TOWN OF SMITHFIELD

**TOWN OF SMITHFIELD
BOARD OF HISTORIC & ARCHITECTURAL REVIEW
AGENDA**

September 20, 2016

**STAFF REPORT FOR THE
BOARD OF HISTORIC AND ARCHITECTURAL REVIEW**

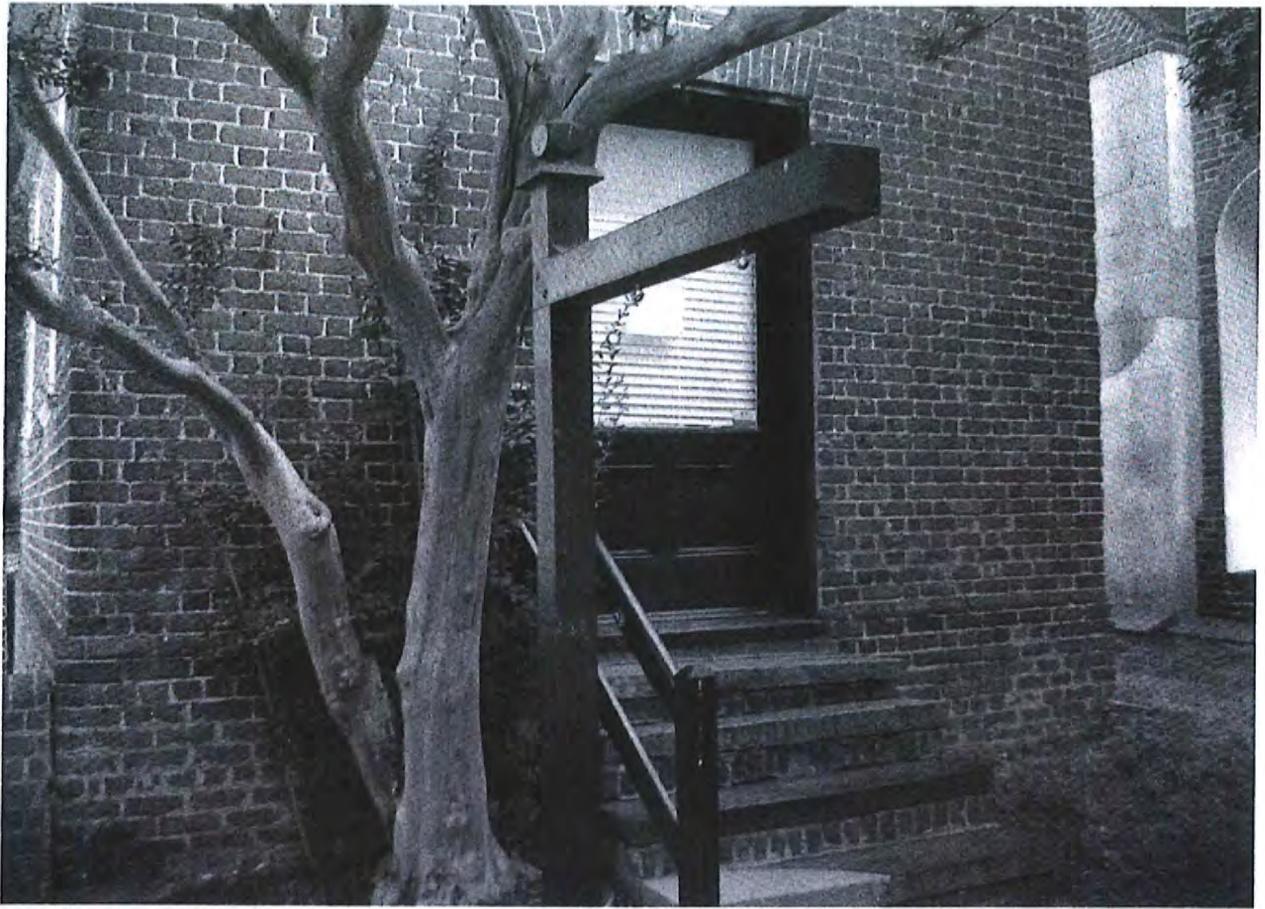
The applicant is seeking BHAR approval to install a new detached sign (7.40 sq. ft.) on the existing sign post in front of the 'Old Clerk's Office' building on 132 Main Street.

The proposed sign is in compliance with the town sign regulations.

Current

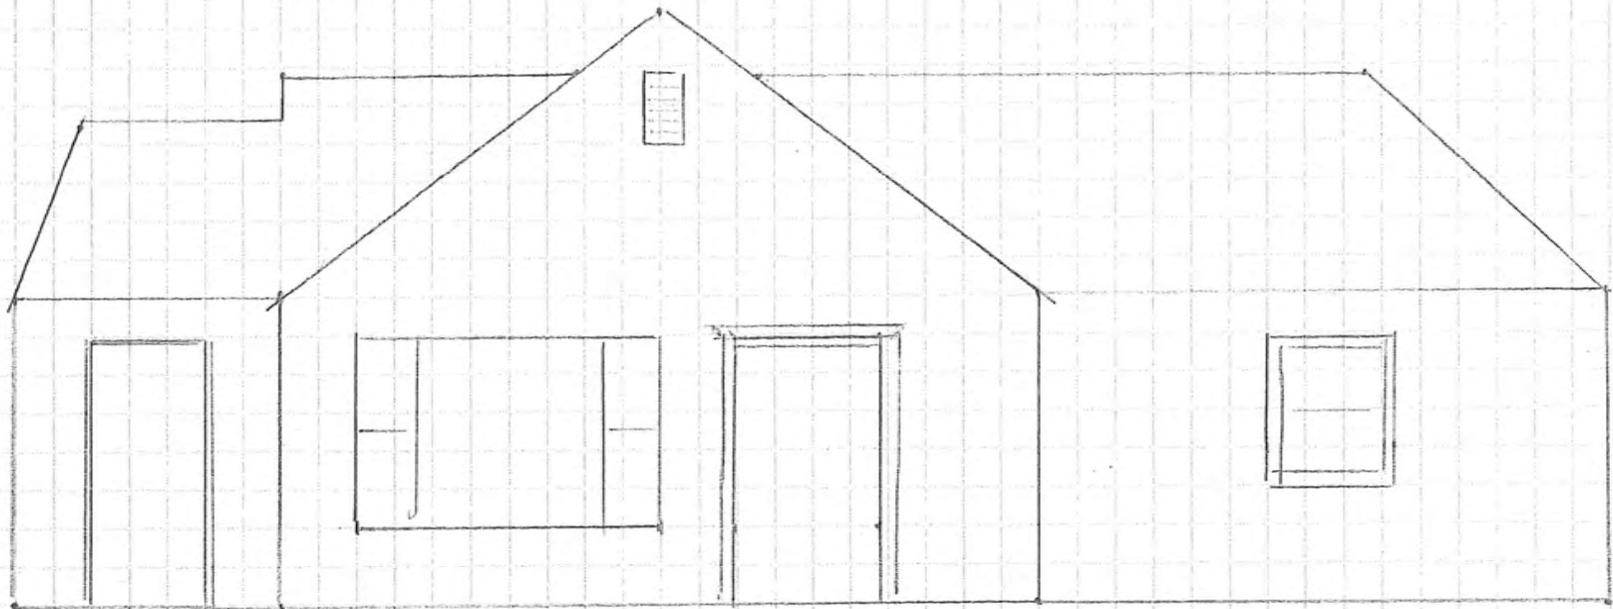
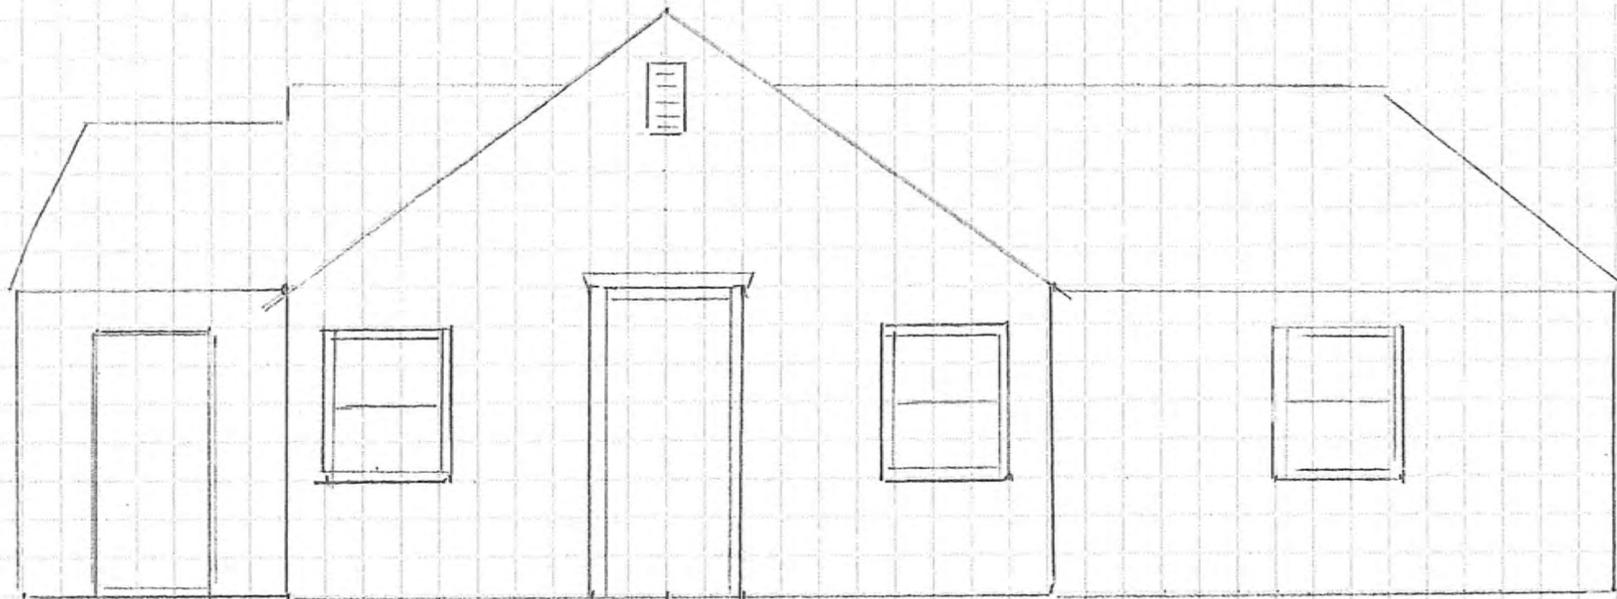
The applicant wishes to change the configuration of the windows and doors on the front of her home; specifically, by removing the asymmetrical bay window to centering the front door and placing a window on either side of the front door in a more symmetrical fashion.

For materials, the applicant intends to reuse the existing windows and intends to use non-asbestos replica cementitious shingles to replace the asbestos cement shingles that will have to be removed in the process.

No color changes are intended.

FRONT ELEVATION

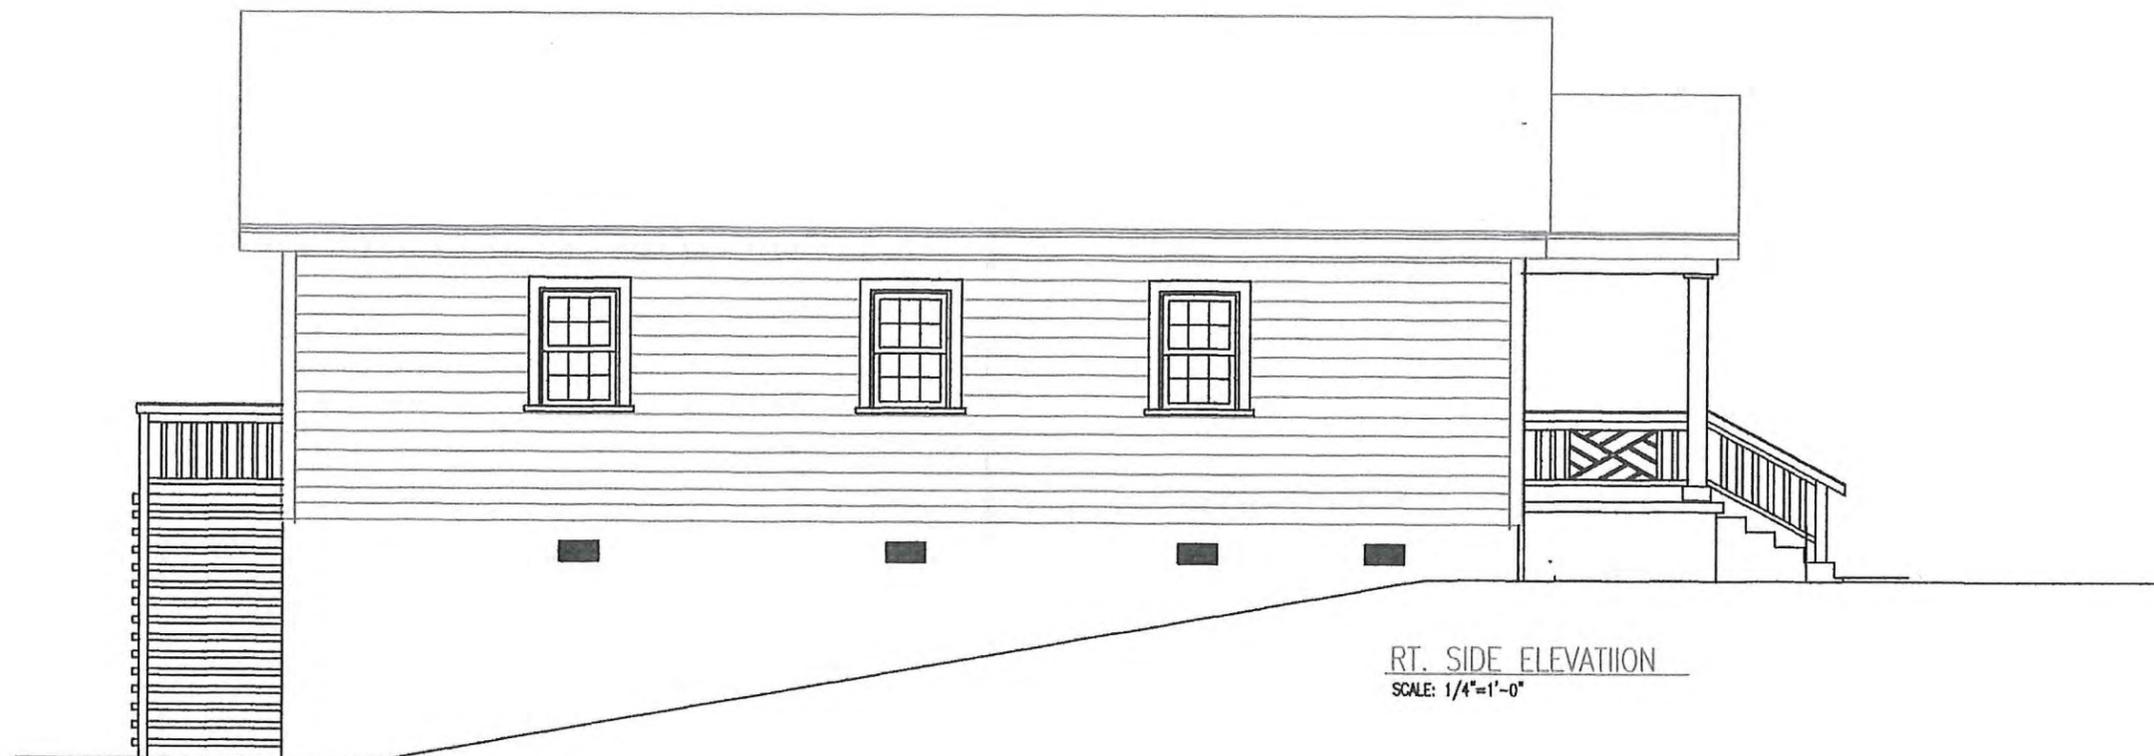
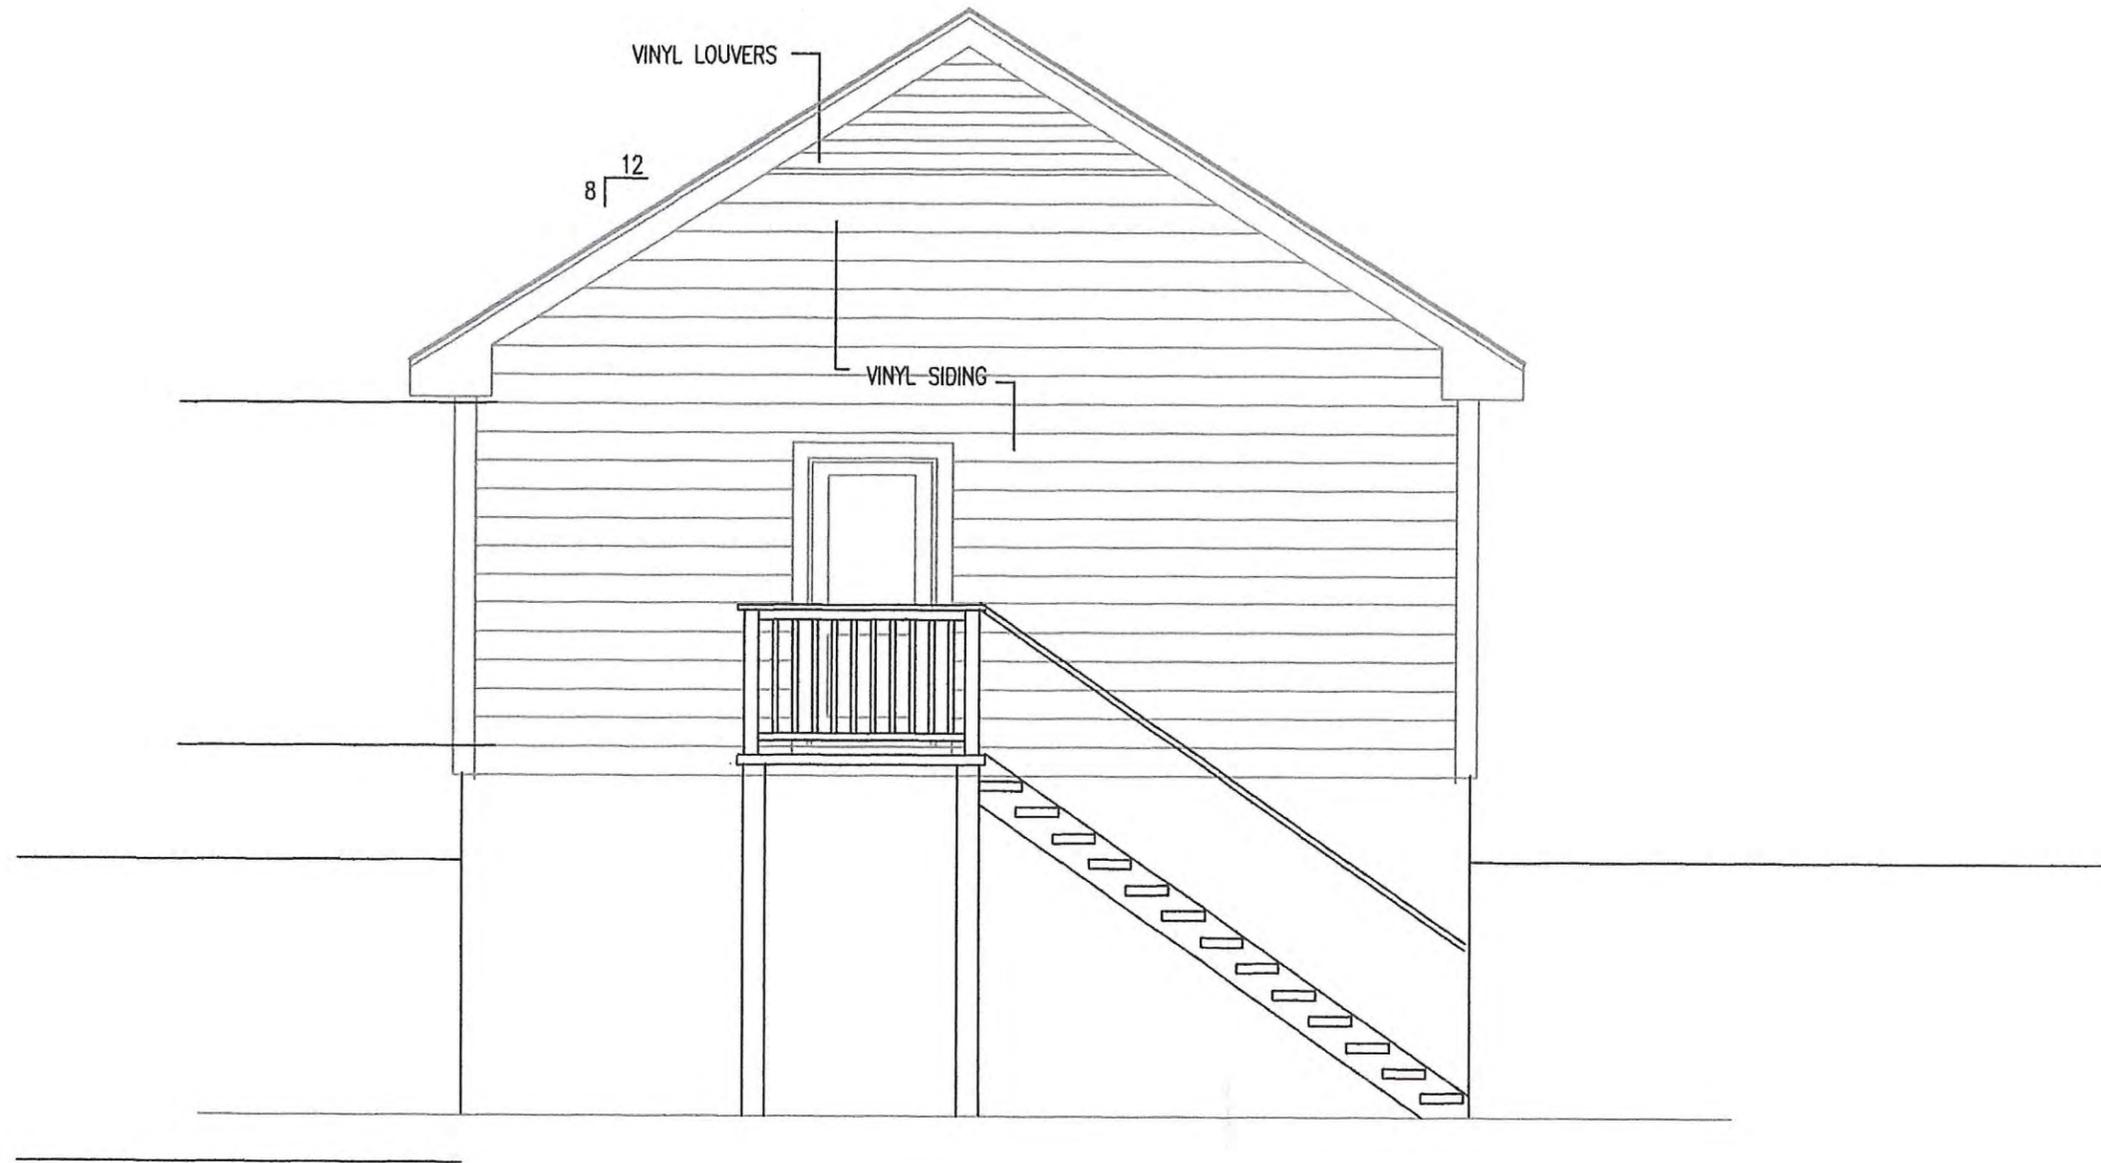
As the result of a destructive house fire, the applicant wishes to demolish the existing non-contributing primary structure and replace it with a new home. The proposed new home would be similar to the existing home and built within the footprint of the existing structure.

*NOTE: The applicant proposes vinyl siding, which has been denied for previous applications.
